IEEE 802.3dg 100BASE-T1L: Downshift/Upshift

Proposed resolution for #255

State Diagram

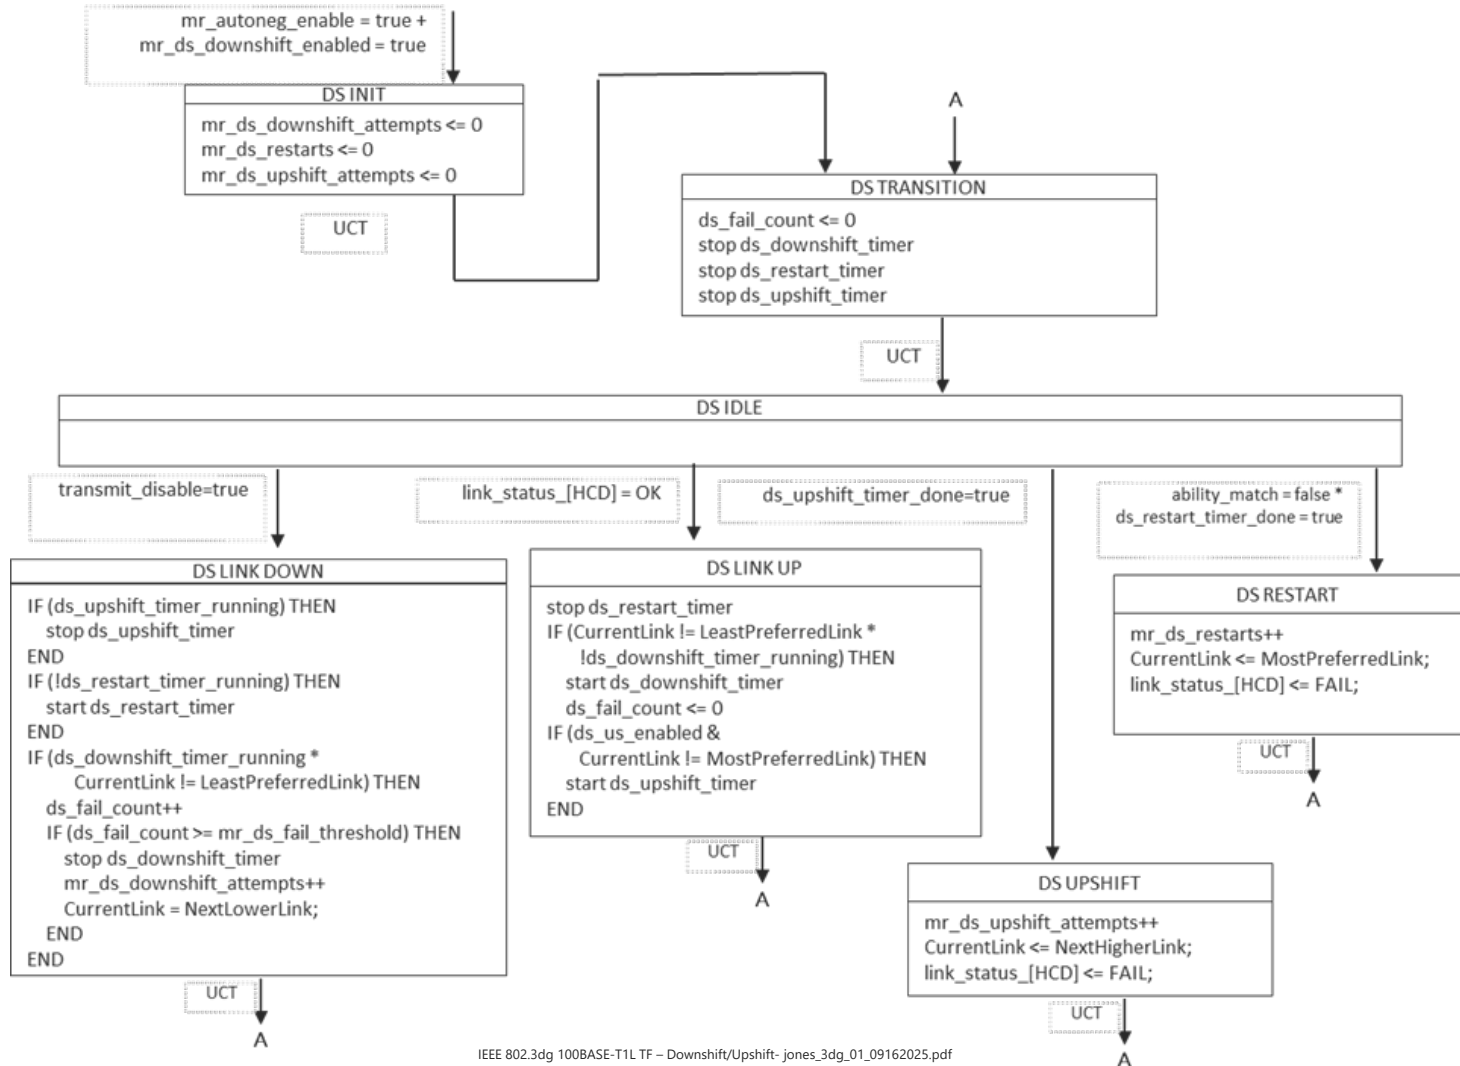
- More than just 10 vs 100, need to account for “Increased Transmit Level”
- Define list of “link settings” entries most to least preferred
- Actions
 - Unstable link -> move to next less preferred
 - Stable link -> move to next more preferred
 - No signaling -> reset downshift
- Mandatory for 100BASE-T1L
- No changes in clause 98, new Normative Annex 98.D
- Matching changes in clauses 45 and 30

- Make changes as per jones_3dg_august_2025_01.pdf pages 7 to 22.
